CALL NO. 100
CONTRACT ID NO. 154100
ADDENDUM # 1

Subject: Laurel County, HSIP 0804 (013)
Letting January 30, 2015

- (1) Revised - Note - Page 41 of 127
- (2) Revised - Typical Section - Pages 54-56 of 127
- (3) Revised - Bid Items - Pages 127-127(a) of 127

SPECIAL NOTE FOR TRENCHING

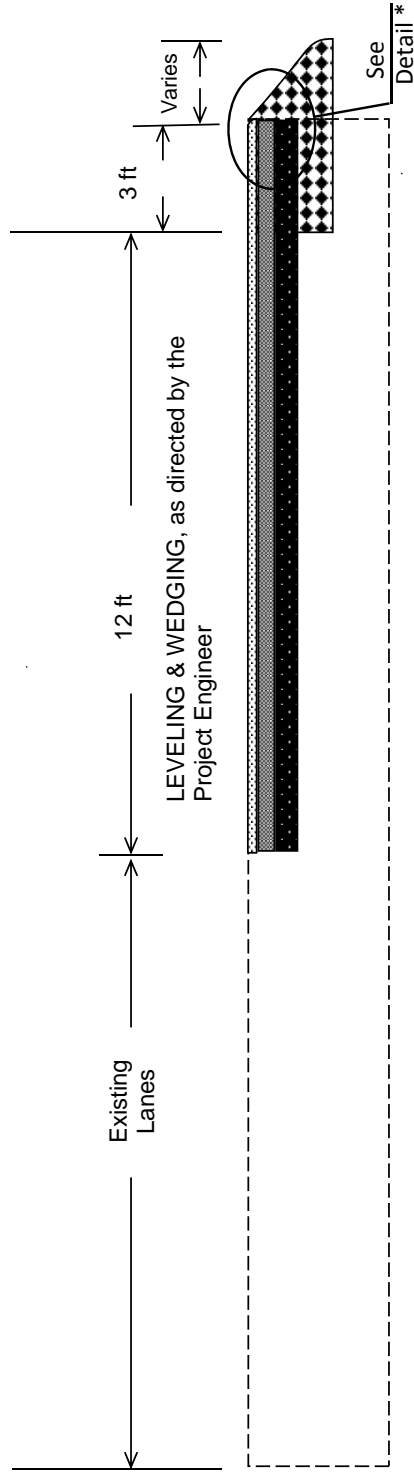
Trench shoulders as shown on the typical section. Reshape and compact excavated material from the trench on the outside edge of the paved shoulder as shown on the typical section. The Department will retain ownership of excess material the Engineer deems suitable for reuse as aggregate and not used to construct the shoulder wedge. Deliver this material to the State Maintenance facility in Laurel County.

Retain possession of materials the Engineer deems unsuitable for reuse and waste the materials off the right-of-way at sites obtained by the Contractor at no additional cost to the Department. See Special Note for Waste and Borrow.

If Trenching is achieved by means other than milling, sawcut the pavement to the desired depth and remove the existing shoulder wedge to create a smooth edge prior to excavating the trench.

The Department will measure "Trenching" in linear feet at the pavement/shoulder edge. The Department will NOT measure saw cutting for payment. The SAWCUT shall be incidental to the bid item TRENCHING. Accept payment at the contract unit price per linear feet as full compensation for all labor, materials, equipment and incidentals for excavating the shoulder trench and reuse, delivery, and/or disposal of the material.

**Typical Section
Sta. 0+00 to 11+40
Sta. 16+40 to 20+30**

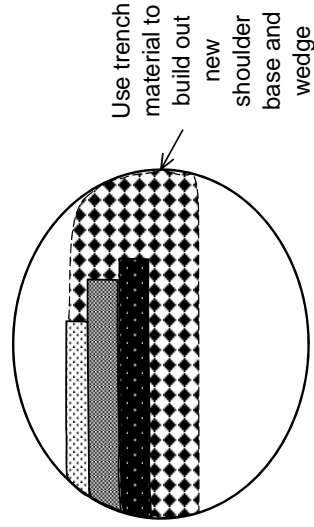
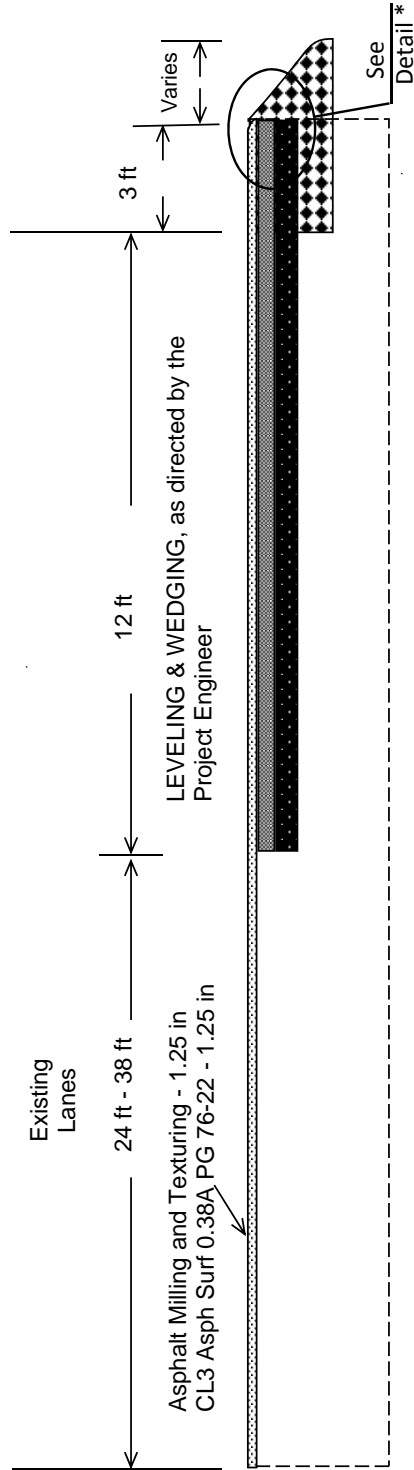
Trenching should be done in a manner to provide a smooth edge, a sub-base of appropriate slopes, and to maintain existing elevation upon completion of final surface.

- 9" - Trenching
- 1.25" CL3 Asph Surf 0.38A PG76-22
- 3.75" CL3 Asph Base 0.75D PG76-22
- 4" CL3 Asph Base 1.0D PG64-22

**Typical Section
Sta. 11+40 to 16+40**

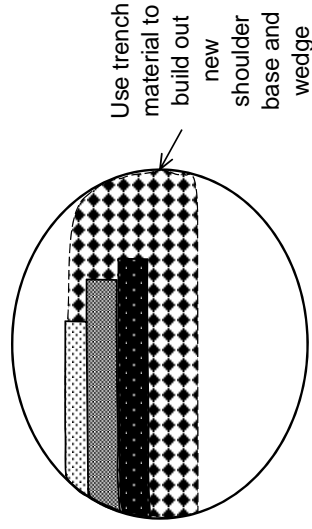
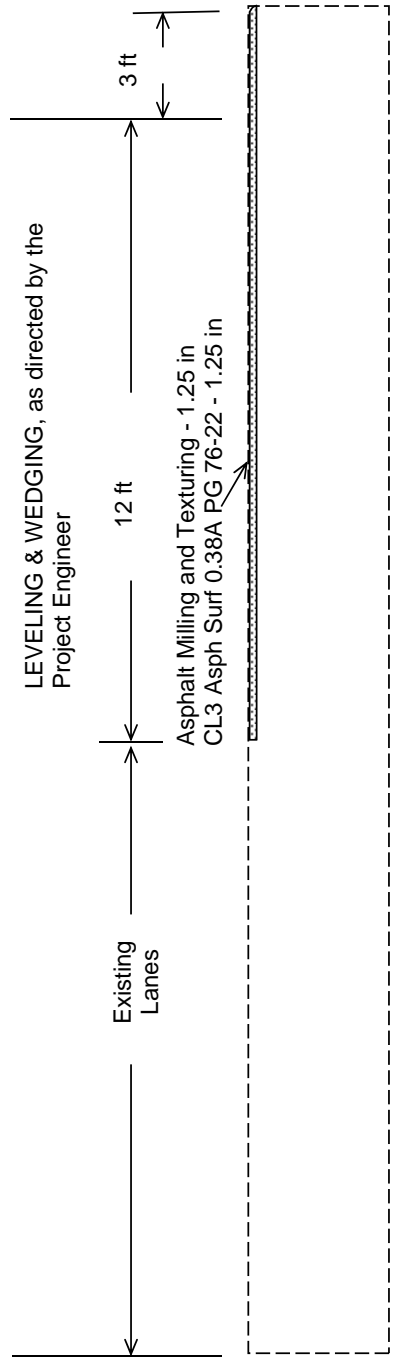
Trenching should be done in a manner to provide a smooth edge, a sub-base of appropriate slopes, and to maintain existing elevation upon completion of final surface.

- 1.25" CL3 Asph Surf 0.38A PG76-22
 - 3.75" CL3 Asph Base 0.75D PG76-22
 - 4" CL3 Asph Base 1.0D PG64-22
- 9" - Trenching
